FINAL DRAFT MINUTES

February 18, 2021 Standards Committee Meeting

RE: Minutes from the February 18, 2021 Standards Committee Meeting

E 801-TCFO-02 MAINTENANCE OF TRAFFIC FOR MOVING OPERATIONS (WITH MARKUPS)

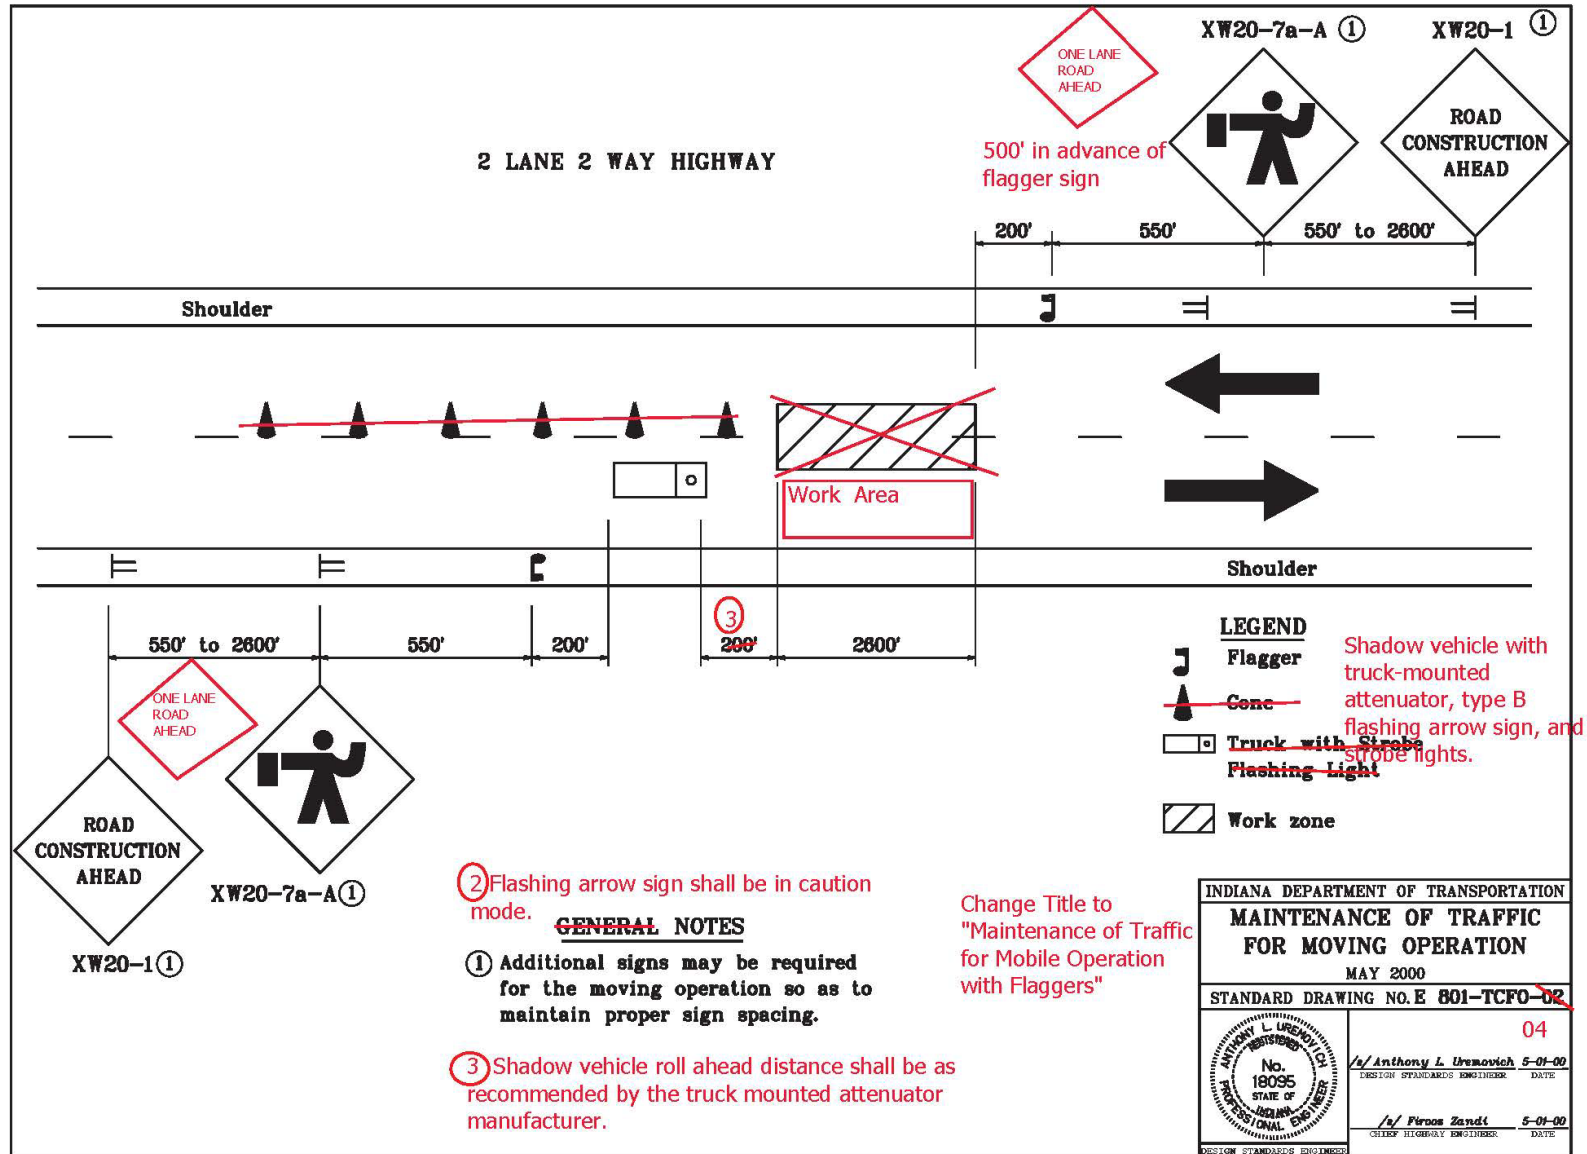
Add index sheet and simplified sheet for flagger operation on two lane road with speed < 50 mph.

E 801-TCFO-03 MAINTENANCE OF TRAFFIC FOR REFLECTOR REPLACEMENT (WITH MARKUPS)

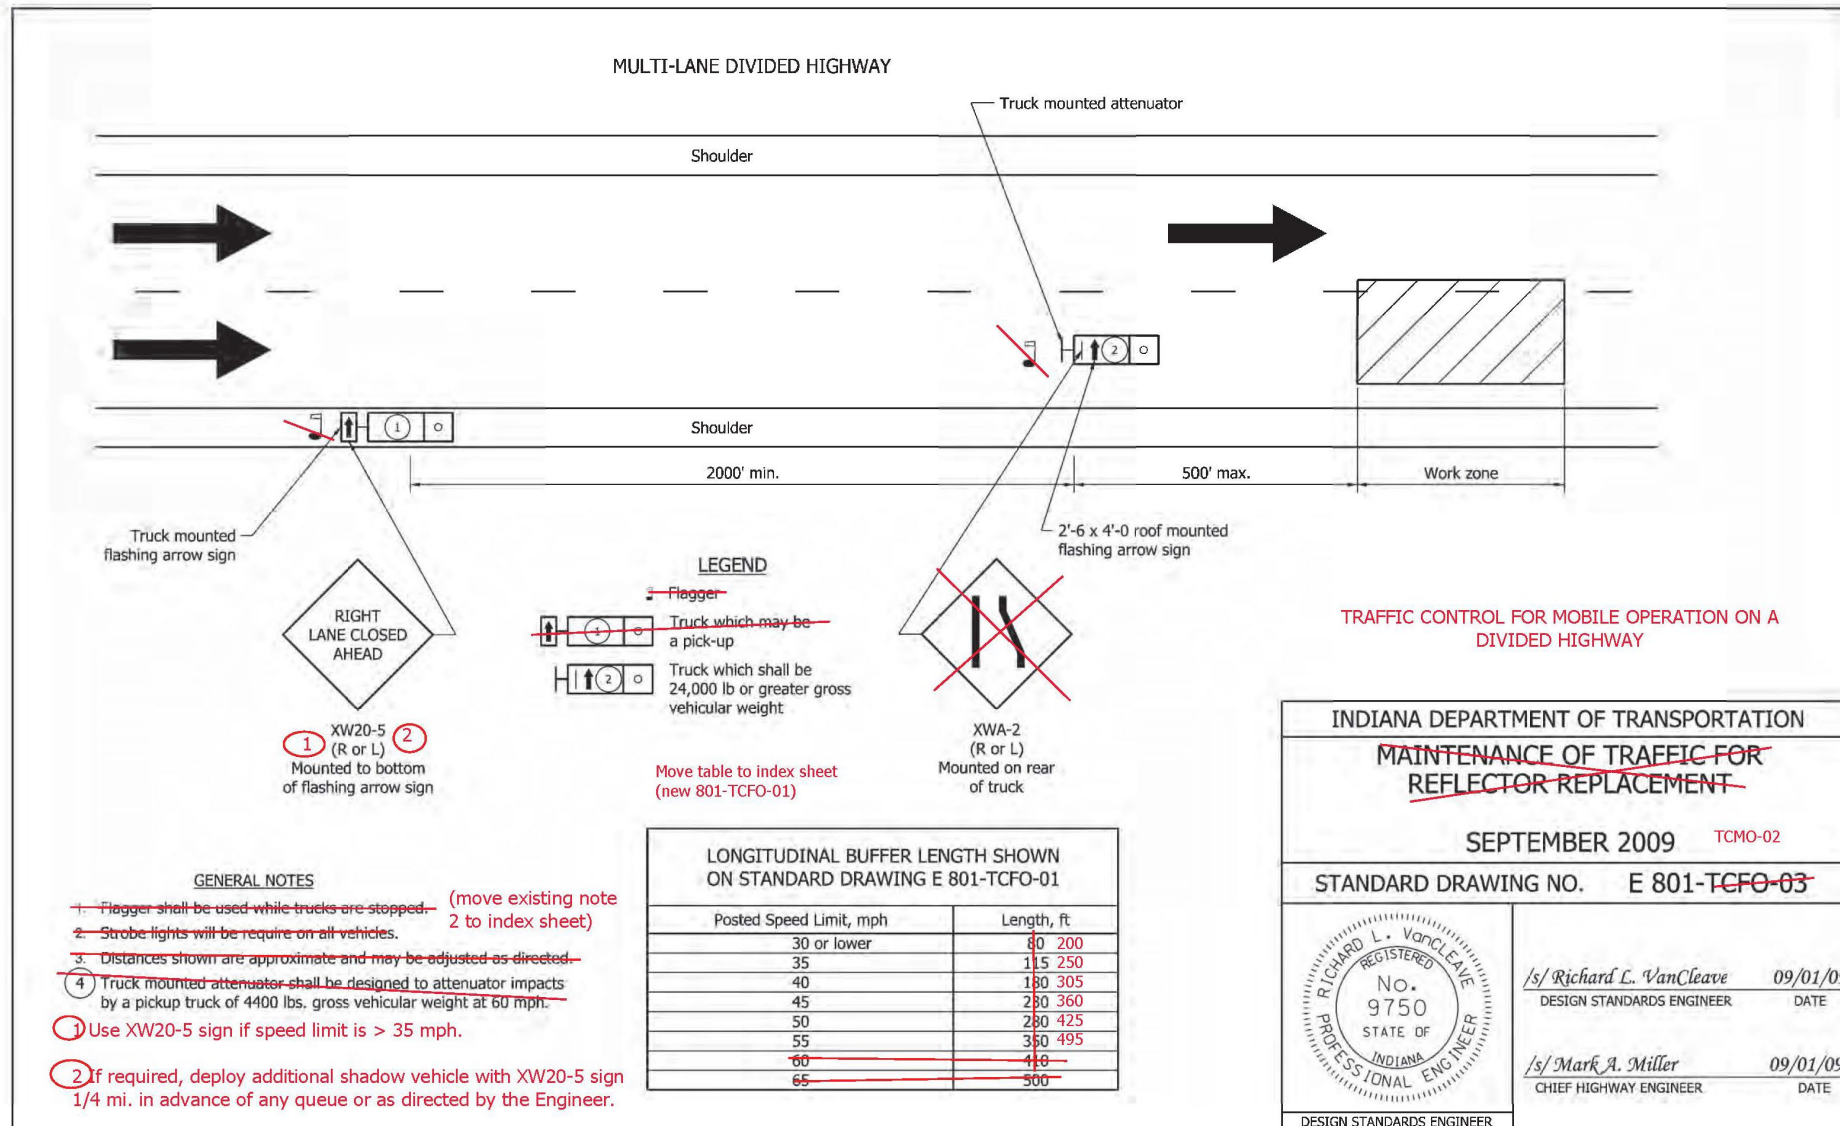
Create New Sheet for Flagging Operations < 50 mph similar to IMUTCD Figure 6H-10

E 801-TCFO-05 TRAFFIC CONTROL FOR OVERHEAD INSTALLATION (WITH MARKUPS)

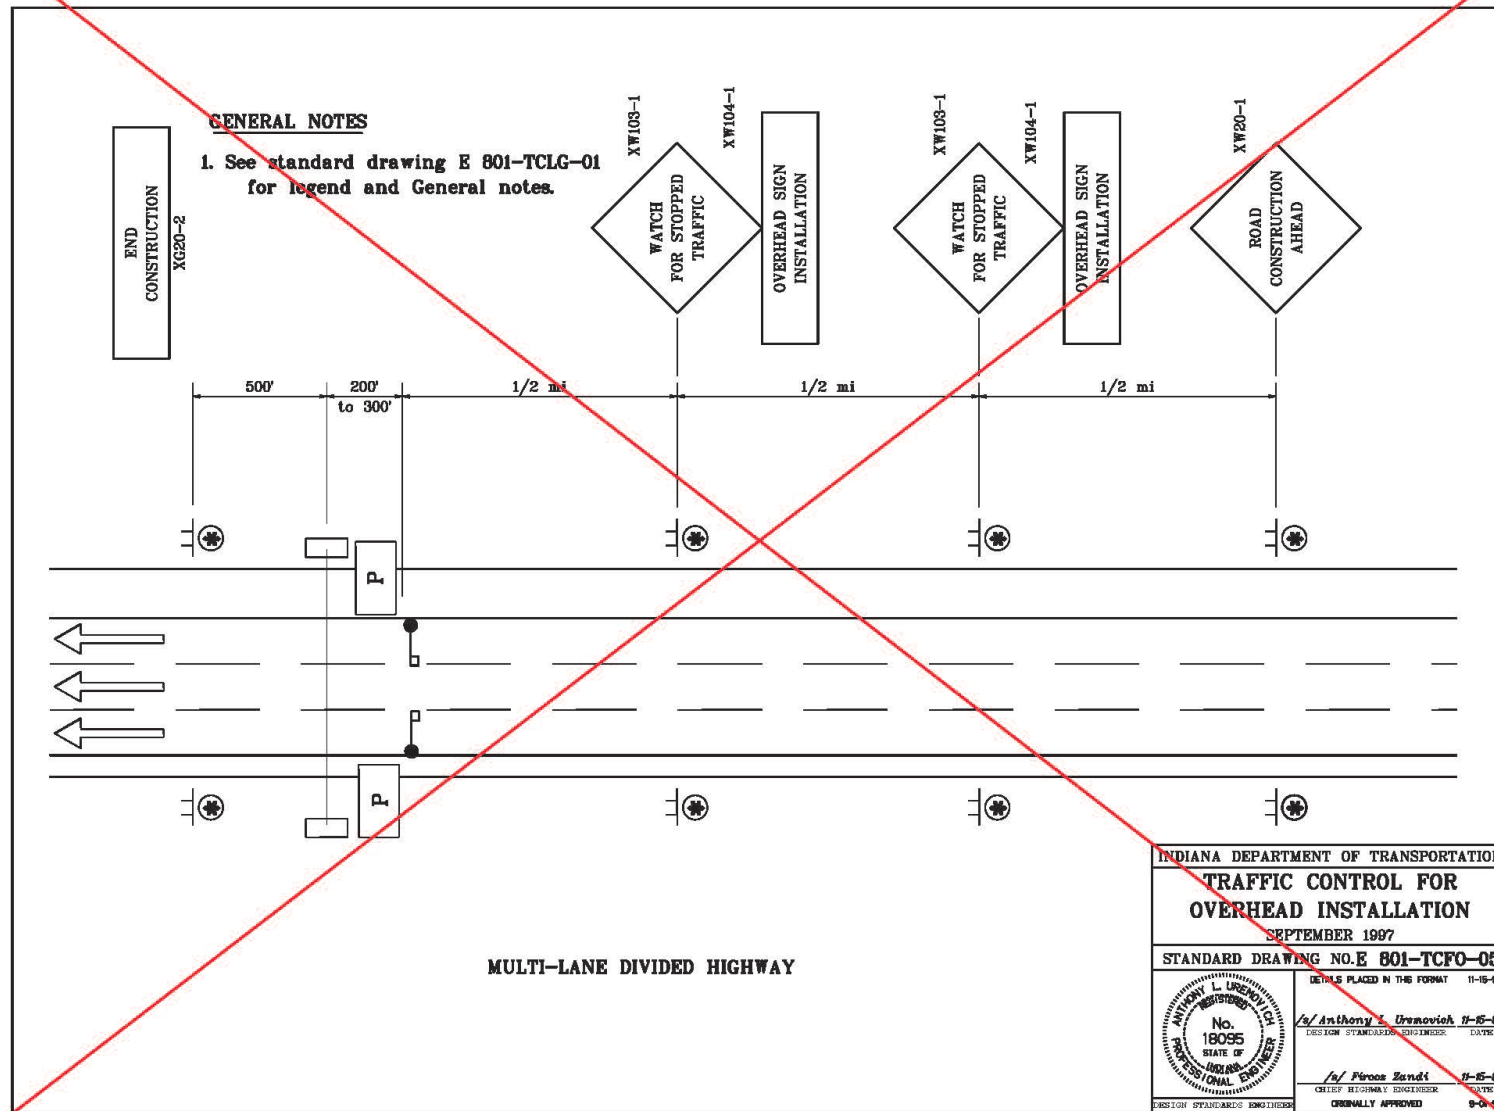
DELETE

E 801-TCFO-06 TRAFFIC CONTROL FOR INTERSECTION WORK (WITH MARKUPS)

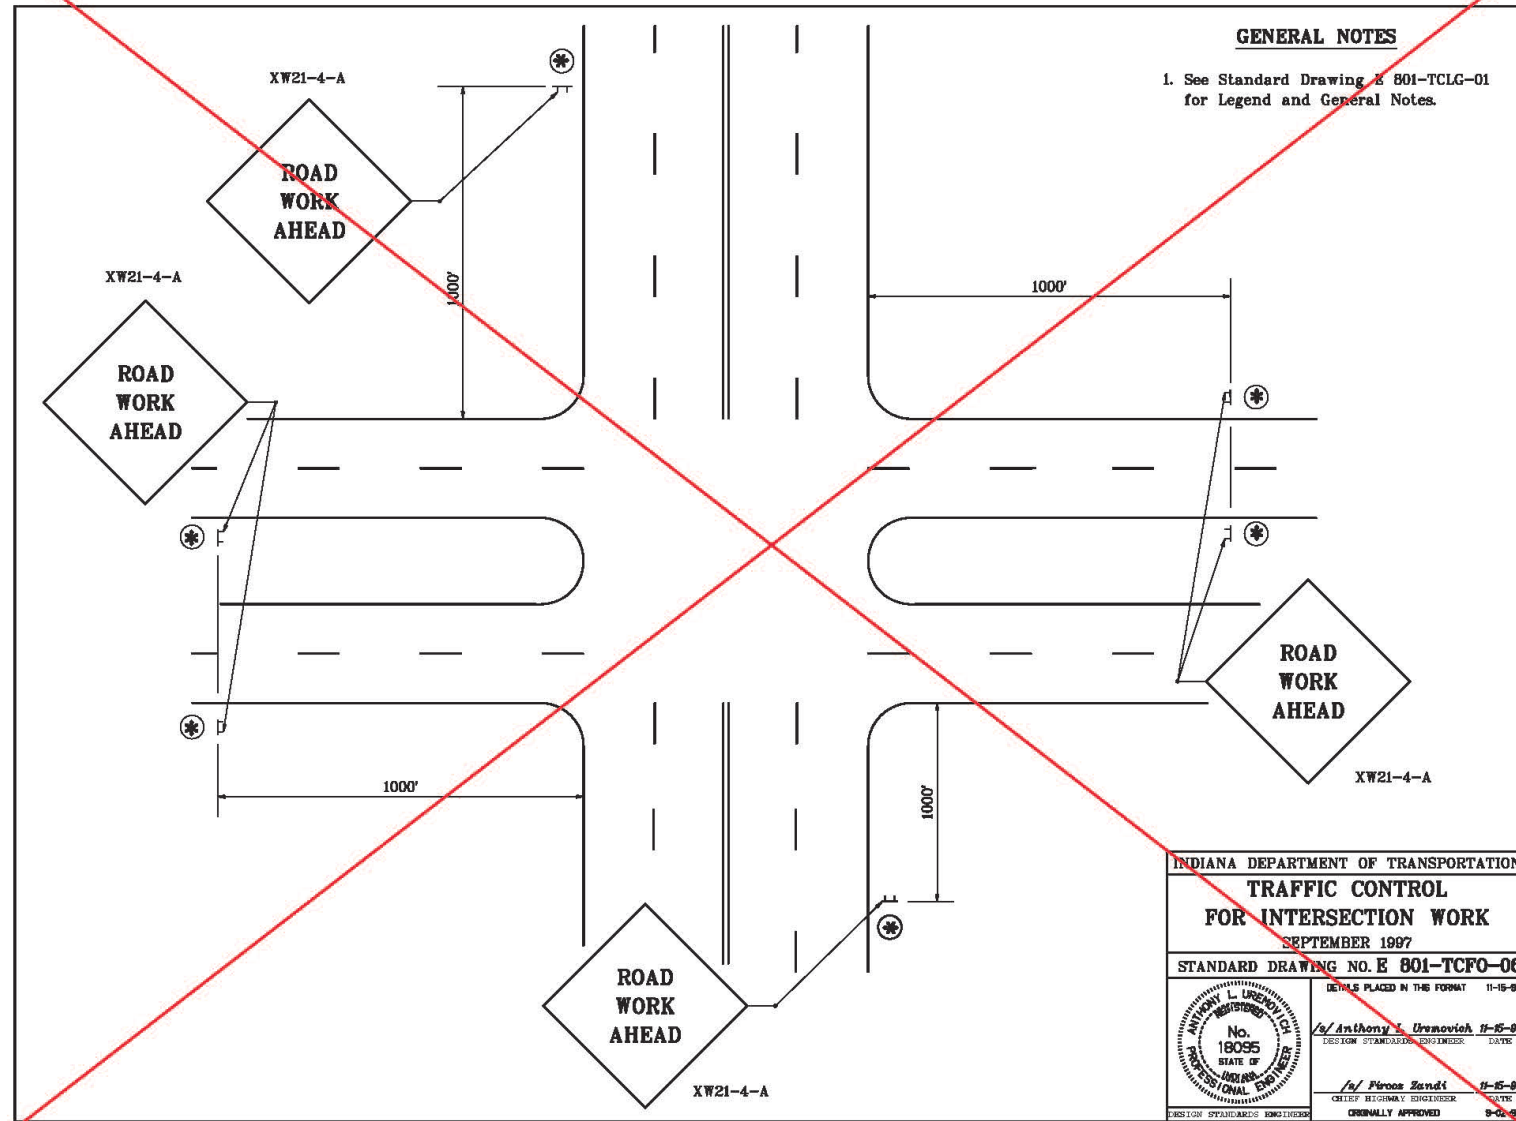
DELETE

E 801-TCTC-05 TRAFFIC CONTROL FOR DAYTIME LANE CLOSURE (WITH MARKUPS)

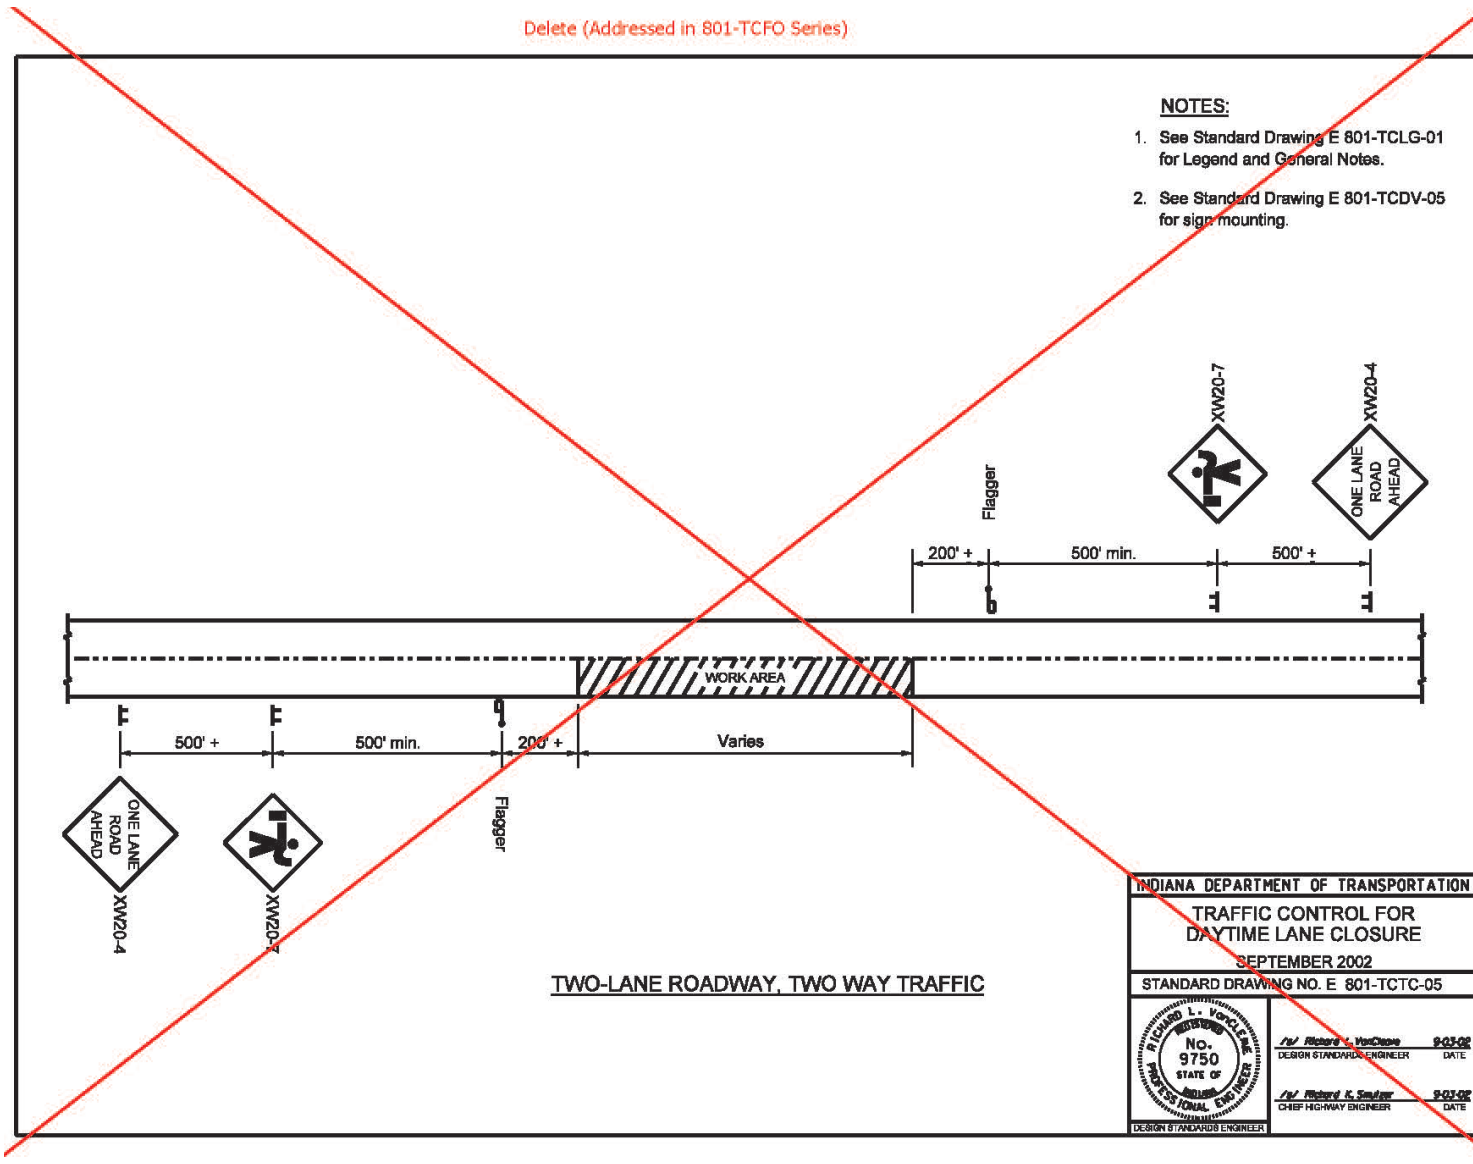
Delete (Addressed in 801-TCFO Series)

E 801-TCTC-06 MAINTENANCE OF TRAFFIC FOR RPM CASTING INSTALLATION (WITH MARKUPS)

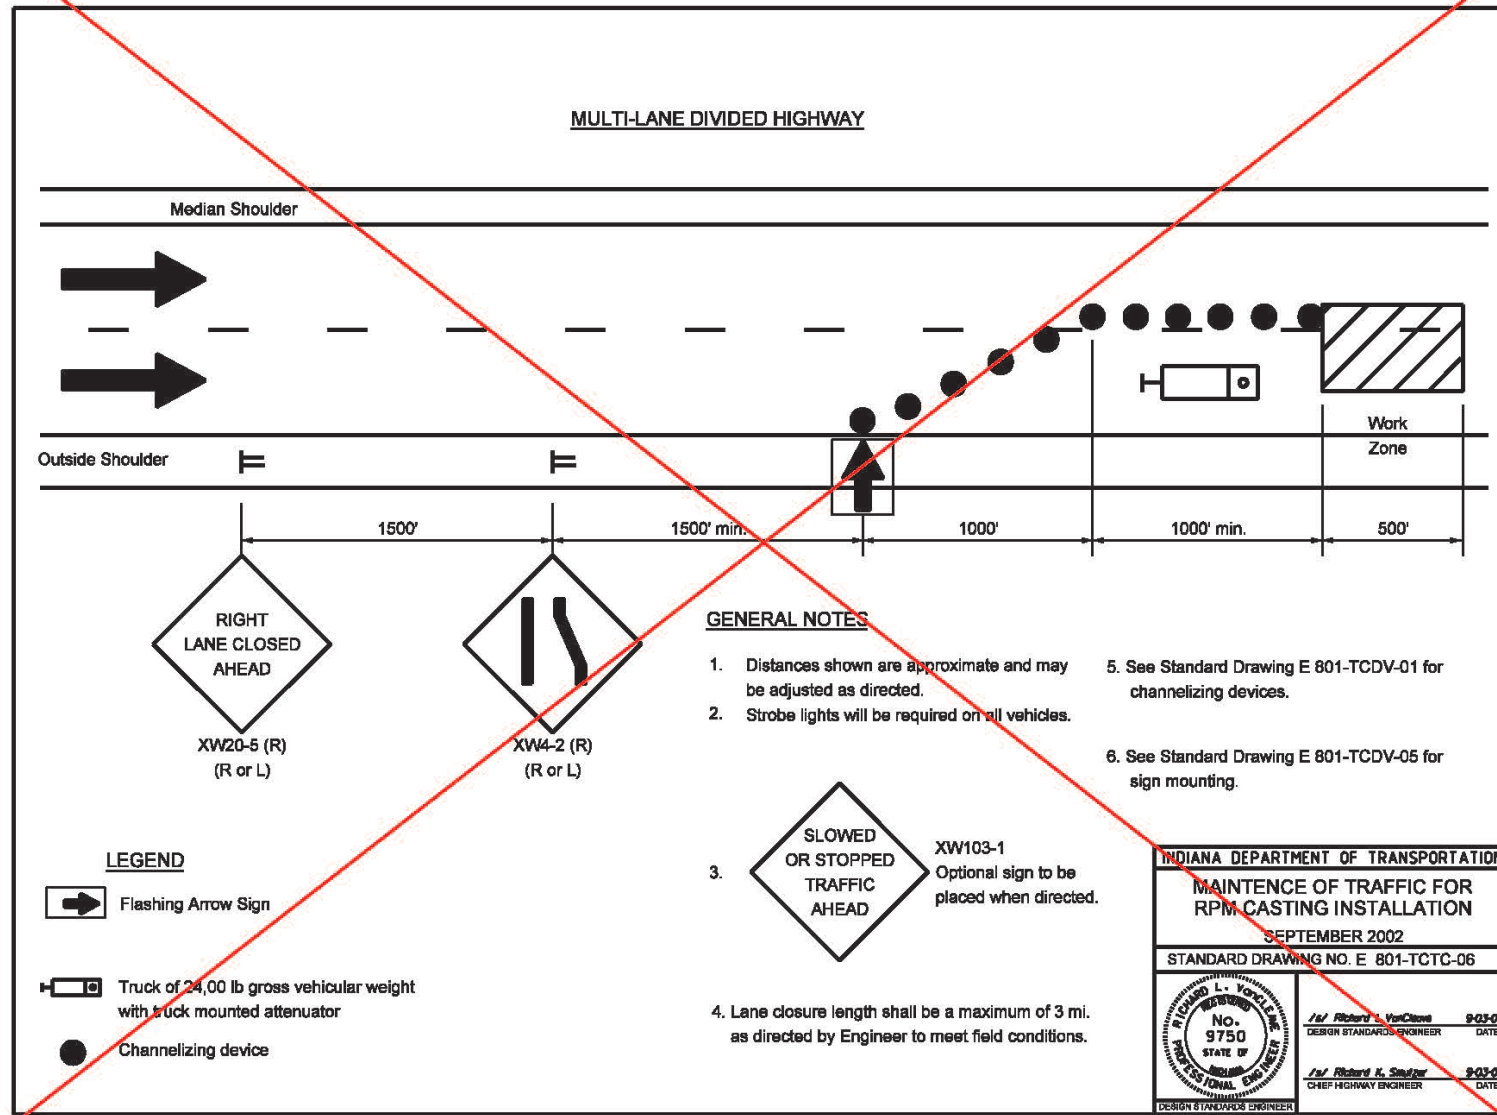
(Duplicate of Existing 801-TCFO-03 and Proposed 801-TCMO-02)
